## REMARKS

Reconsideration of the above-identified application is respectfully requested.

FIG.1

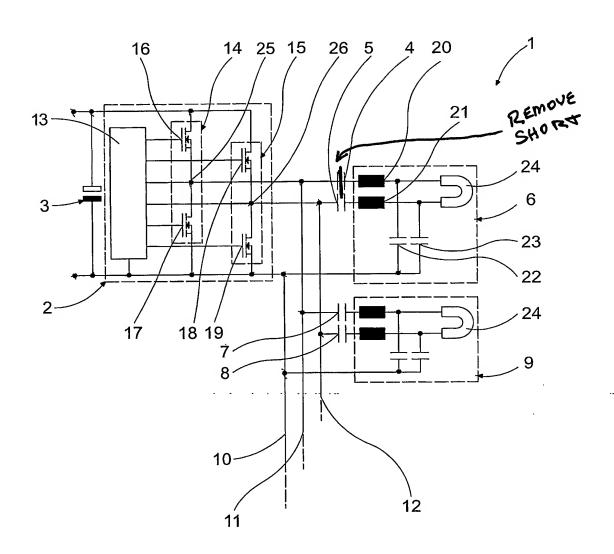
The shorting of capacitor 4 (FIG. 1) is also corrected in the drawing. A replacement sheet of drawings is enclosed. A copy of FIG. 1 showing the change in red is also enclosed.
